EC45-07/08

402.2.1, 402.2.2; IRC N1102.2.1, N1102.2.2

Proponent: Ronald Majette, U.S. Department of Energy

Potential net energy savings from changing roof reflectivity. Savings are measured in dollars. The net savings are the savings of cooling energy use less the penalties of heating energy use.

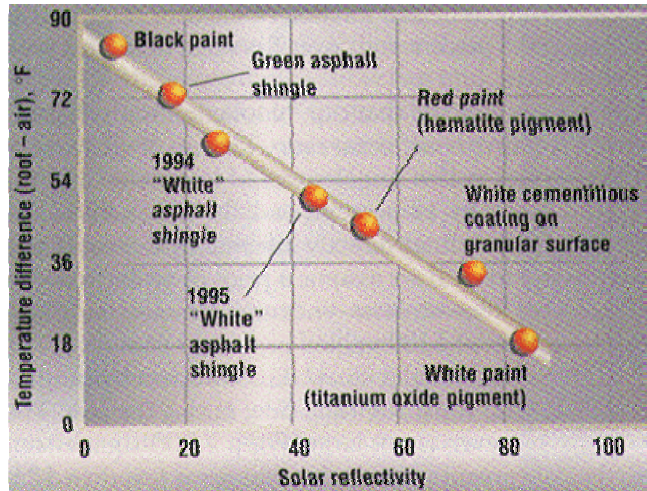
Reason: Dark materials absorb more heat from the sun. Black surfaces in the sun can become up to 70°F (40°C) hotter than the most reflective white surfaces. If those dark surfaces are roofs, some of the heat collected by the roof is transferred inside. Staying comfortable under a dark shingle roof often means more air conditioning and higher utility bills. These roofs also heat the air around them, contributing to the heat island effect. Conversely, cool roofs can reduce the heat island effect and save energy. In a study funded by the U.S. EPA, the Heat Island Group carried out a detailed analysis of energy-saving potentials of light-colored roofs in 11 U.S. metropolitan areas. About ten residential and commercial building prototypes in each area were simulated. Energy Star considered both the savings in cooling and penalties in heating. We estimated saving potentials of about \$175 million per year for the 11 cities. Extrapolated national energy savings were about \$750 million per year.

The Heat Island Group has monitored buildings in Sacramento with lightly colored, more reflective roofs and found that these buildings used up to 40% less energy for cooling than buildings with darker roofs. The [Florida Solar Energy Center](#) performed a similar study, also showing up to 40% cooling energy savings.

Add new text as follows:

1. The portion of the roof that is covered by a rooftop deck covering 1/3 or less of the aggregate area of the roof, or a rooftop garden, or a green roof.
2. An area including and adjacent to rooftop photovoltaic and solar thermal equipment, totaling not more than three times the area that is covered with such equipment.
